BROWNS FERRY NUCLEAR PLANT UNIT 1

AMENDMENT TO FACILITY OPERATING LICENSE

Amendment No. 197
License No. DPR-33

ATTACHMENT TO LICENSE AMENDMENT NO. 197

Figure 3.5.M-1
BFN Power/Flow Stability Regions

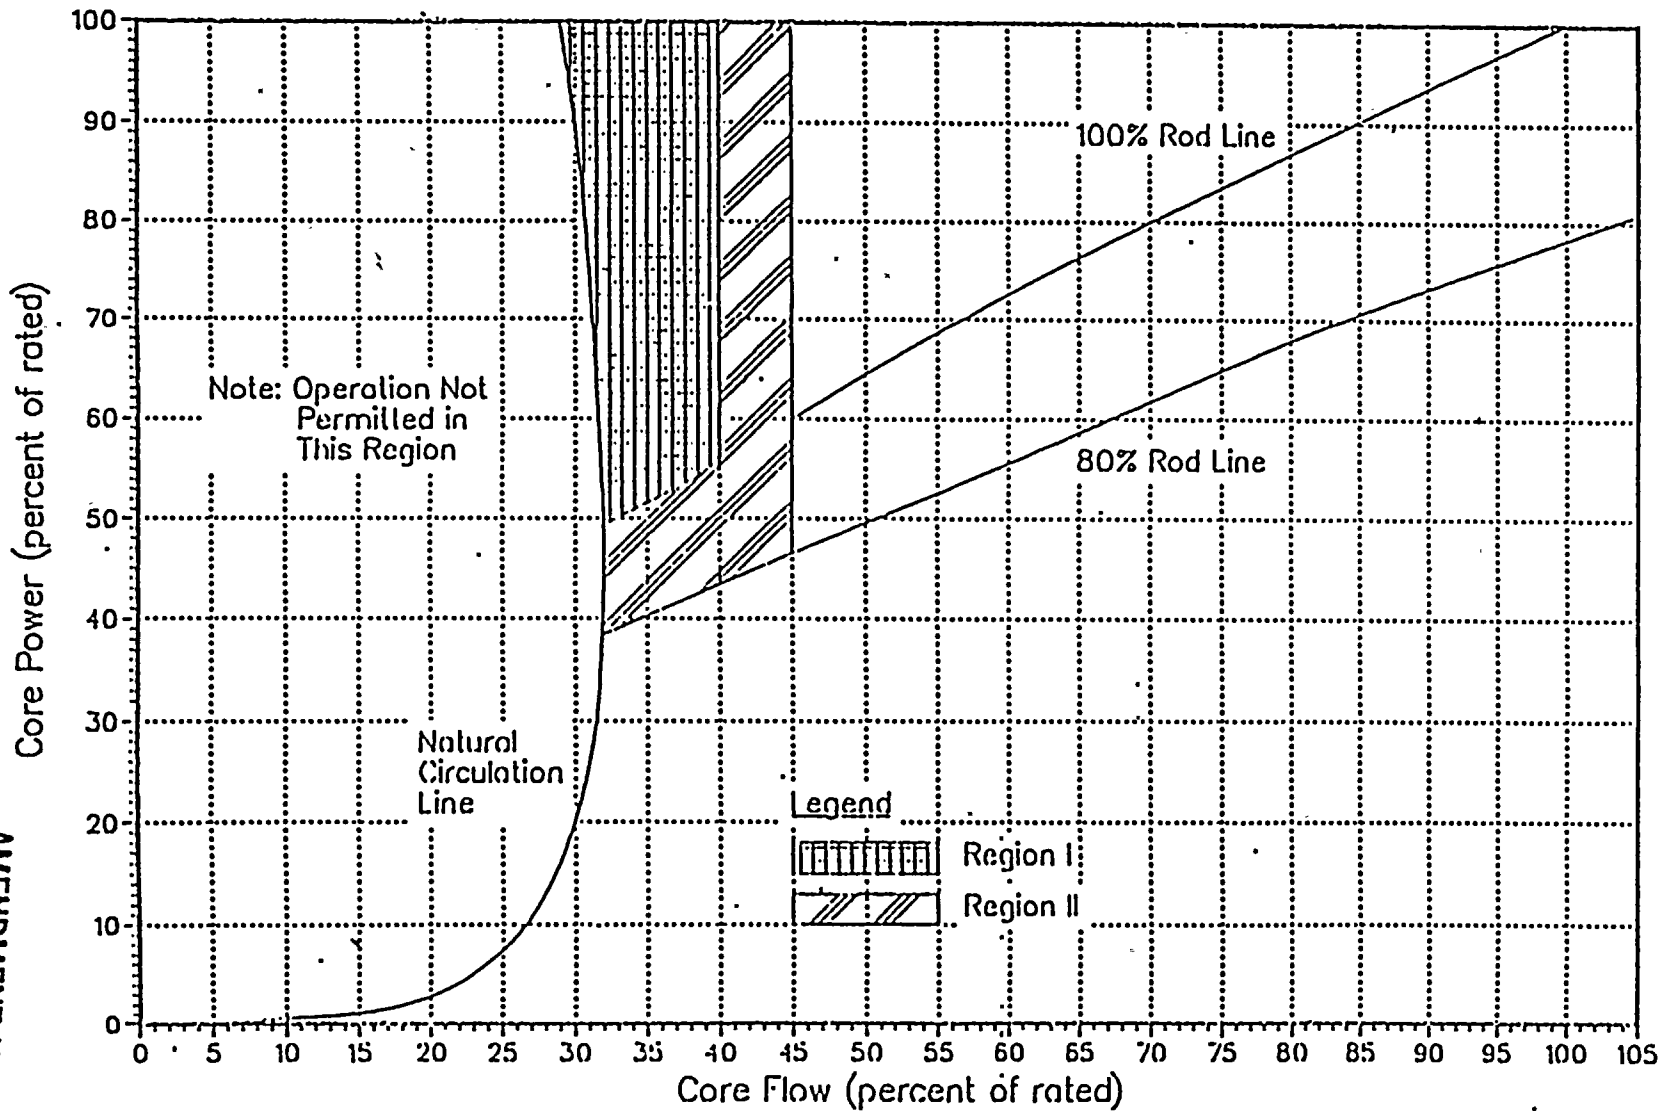
The minimum margin to the onset of thermal-hydraulic instability occurs in Region I of Figure 3.5.M-1. A manually initiated scram upon entry into this region is sufficient to preclude core oscillations which could challenge the MCPR safety limit.

Because the probability of thermal-hydraulic oscillations is lower and the margin to the MCPR safety limit is greater in Region II than in Region I of figure 3.5.M-1, an immediate scram upon entry into the region is not necessary. However, in order to minimize the probability of core instability following entry into Region II, the operator will take immediate action to exit the region. Although formal surveillances are not performed while exiting Region II (delaying exit for surveillances is undesirable), an immediate manual scram will be initiated if evidence of thermal-hydraulic instability is observed.
